**ZONING AMENDMENT
& SUBDIVISION STAFF REPORT****Date: October 7, 2010****APPLICANT NAME**

The College Business Park Subdivision

LOCATION121 West I-65 Service Road North
(West side of West I-65 Service Road North, 205'± North
of College Lane South)**CITY COUNCIL
DISTRICT**

DETAIL SITE PLAN

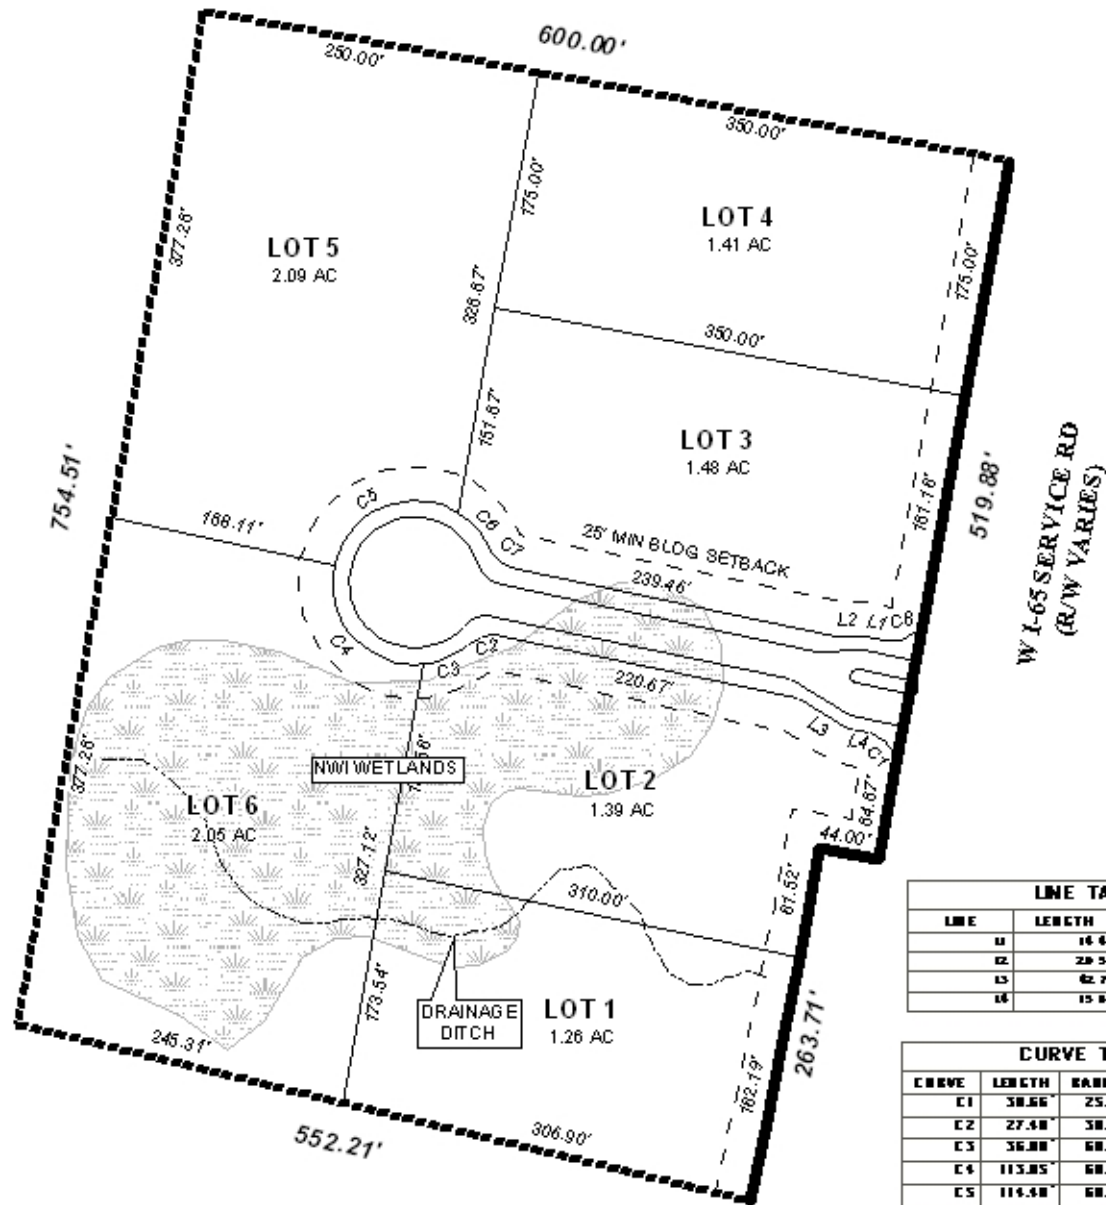
Need to provide a drainage easement for the existing 36" storm drain, the width of the easement to be approved by the City Engineer. Must comply with

Driveway number, size, location, and design to be approved by Traffic Engineering and conform to AASHTO standards. A Traffic Impact Study is required to be submitted for this development.

The proposed lots are of sufficient size and have sufficient public right-of-way frontage to be compliant with the requirements of the Subdivision Regulations. The lot area sizes are depicted on the plat and should be retained on the Final Plat, if approved.

Lots 1 and 4 front along West I-65 Service Road North with less than 200' of frontage and should, therefore, be limited to one curb cut each. Lots 2 and 3 front both West I-65 Service Road North and the proposed cul-de-sac street and both would have over 200' of frontage; therefore, Lots 2 and 3 should be limited to two curb cuts each to the cul-de-sac street only. Lots 5 and 6 would front only the proposed cul-de-sac and should, therefore, be limited to one curb cut each. A note should be placed on the final plat stating that the driveway number, size, location, and design are to be approved by Traffic Engineering and conform to AASHTO standards. Traffic Engineering has required a Traffic Impact Study be submitted for this development. This should be submitted prior to any approval of this subdivision.

The 25-foot minimum building setback is depicted for all lots and should be retained on the Final Plat, if approved.

The legal description furnished is metes-and-bounds but describes Lot 2, Springhill Apartments Subdivision. This should be revised to state the recorded legal description Lot 2, Springhill Apartments Subdivision. That recorded plat also indicates drainage and/or utility easements not shown on the preliminary plat; therefore, the plat should be revised to show all easements on the property. The legal description should be corrected on the Final Plat, if approved, as well as the rezoning request.
